SUBJECT:  
PROPOSED MODIFICATION OF THE HIGH PRESSURE INJECTION SYSTEM AT SUBJECT  
FACILITY WHICH IS INTENDED TO EFFECTIVELY MITIGATE SMALL BREAK LOCA

O C O N E E   N U C L E A R   S T A T I O N

PROPOSED MODIFICATION  
OF  
HIGH PRESSURE INJECTION SYSTEM

OCONEE NUCLEAR STATION  
UNITS 1, 2 AND 3  
PROPOSED MODIFICATION OF HIGH PRESSURE INJECTION SYSTEM

FIGURE 1  
OCONEE NUCLEAR STATION  
PROPOSED MODIFICATION OF HPI SYSTEM

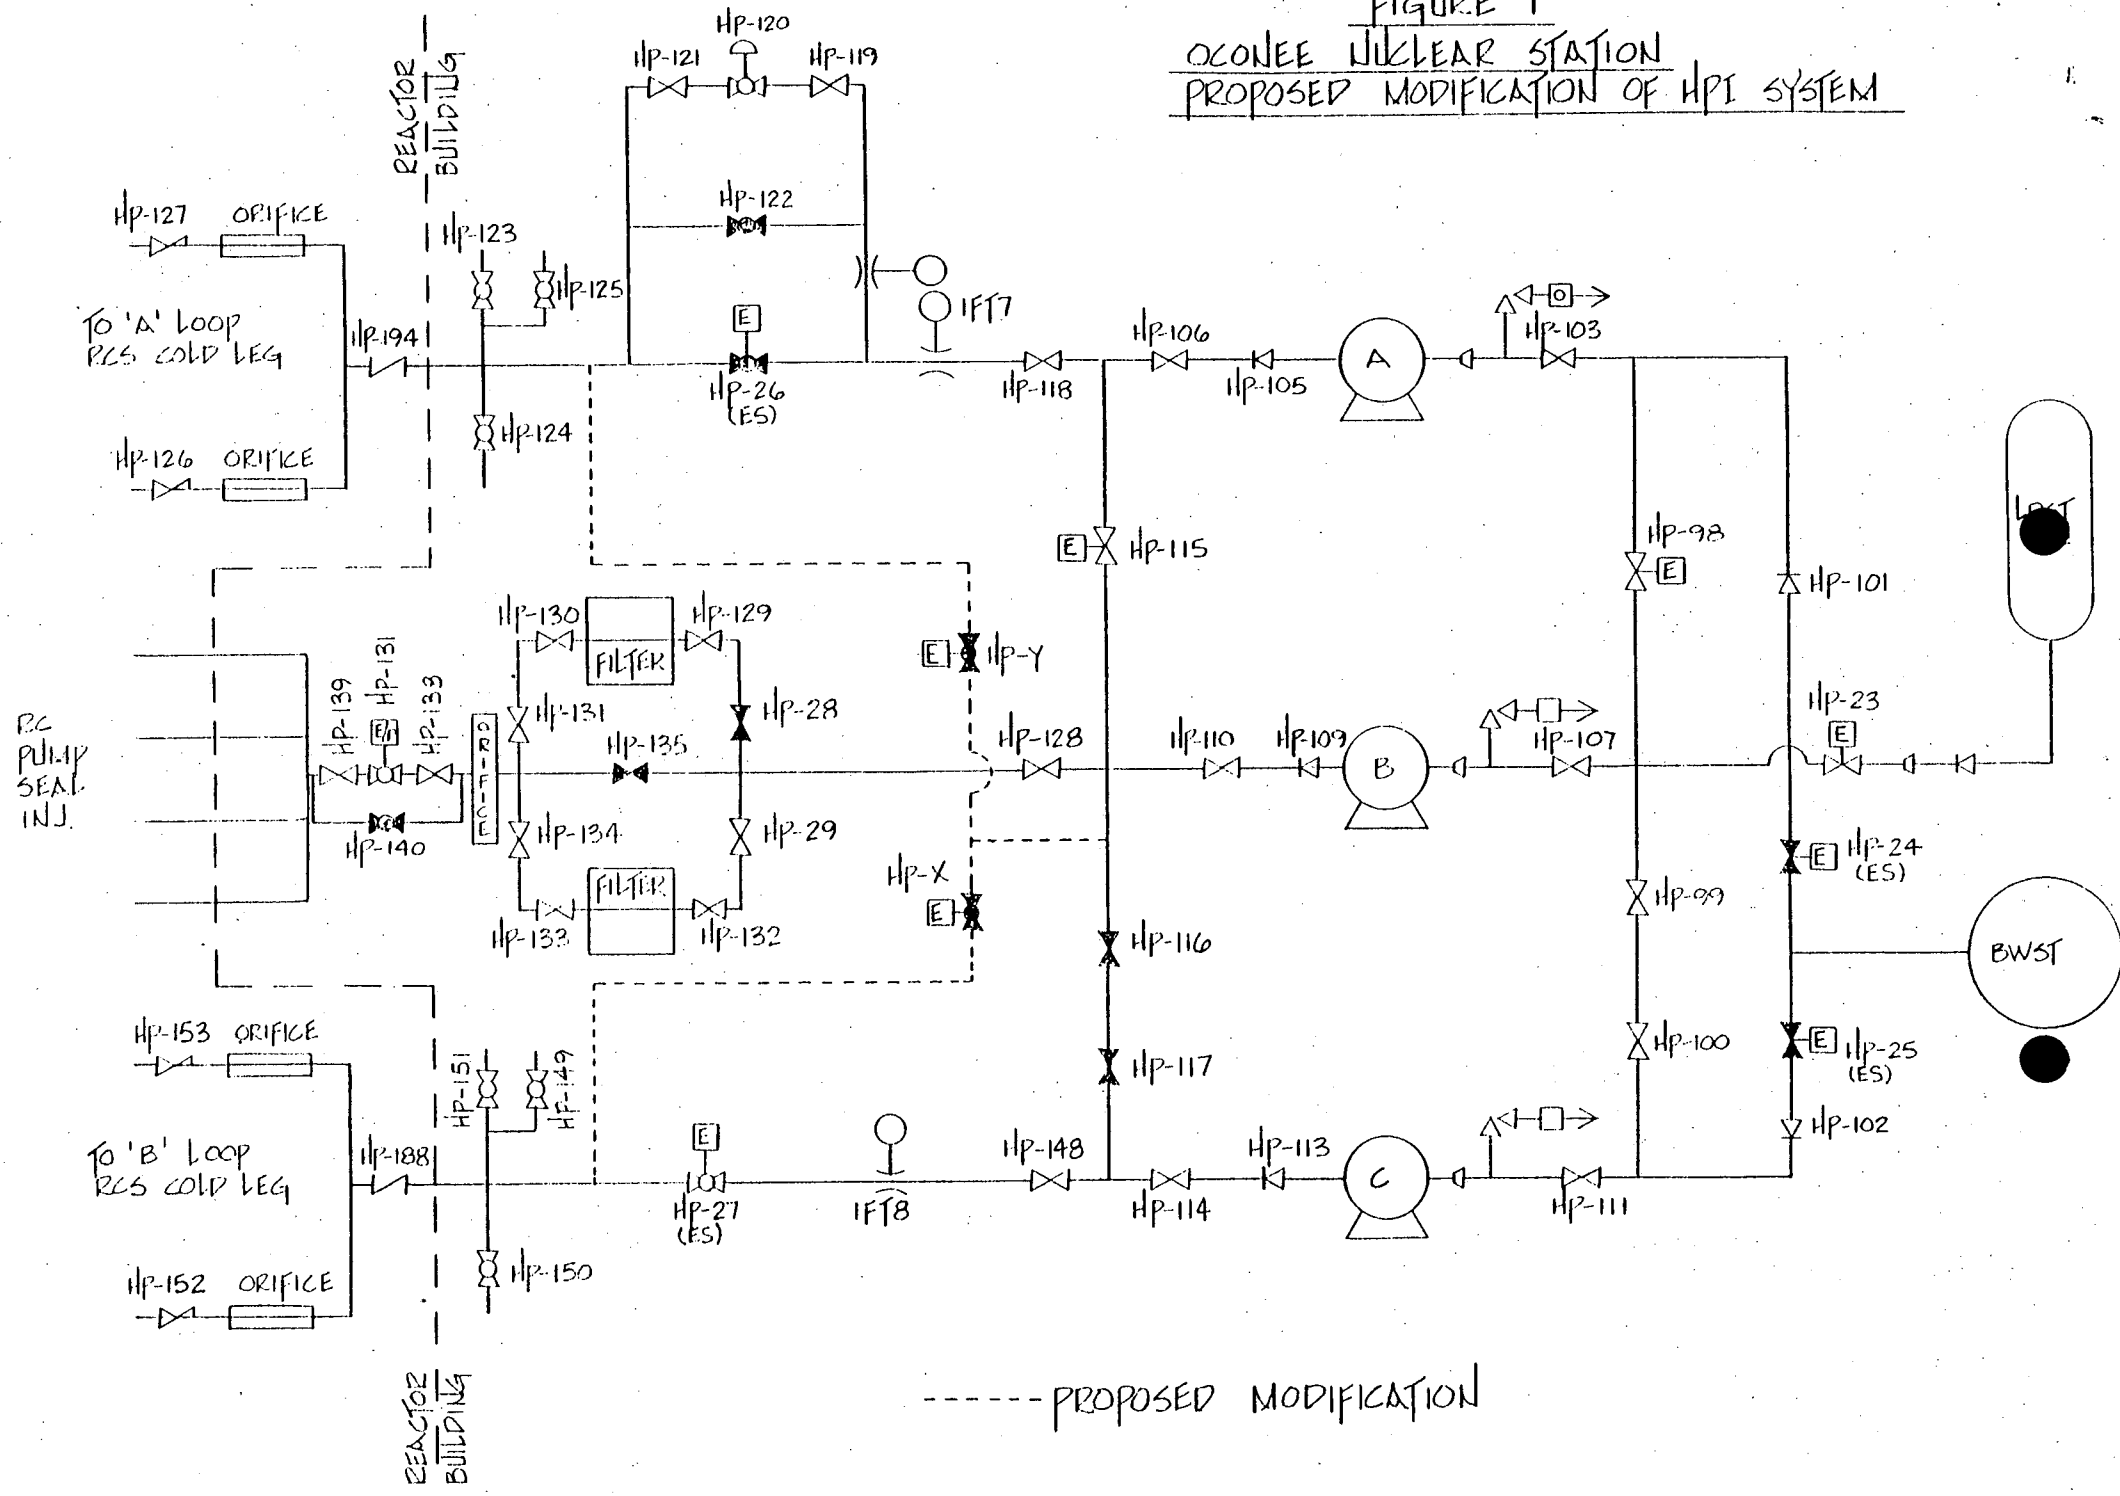
The proposed modification consists of installing a cross-connect line between the A and B HPI discharge lines downstream from the ES valves

(HP-26 and HP-27) and another tie-line connecting this cross-connect line and the HPI pumps B-C discharge header with isolation valves, as shown in Figure 1. The isolation valves HPI-X and HPI-Y (temporary designations) will be manually-controlled, electrically-operated valves (EMO valves) capable of being manipulated from the control room. The operators of these valves will be powered by a source of power supply independent of that supplying power to the HPI-A and HPI-B flow trains.

The only operator action required for the modified HPI system is the opening of the isolation valves HPI-X and HPI-Y following an ES actuation. The allowable time to accomplish this function is ten minutes. Since the controls for these valves will be located within the control room, the operator can accomplish this function promptly and easily.
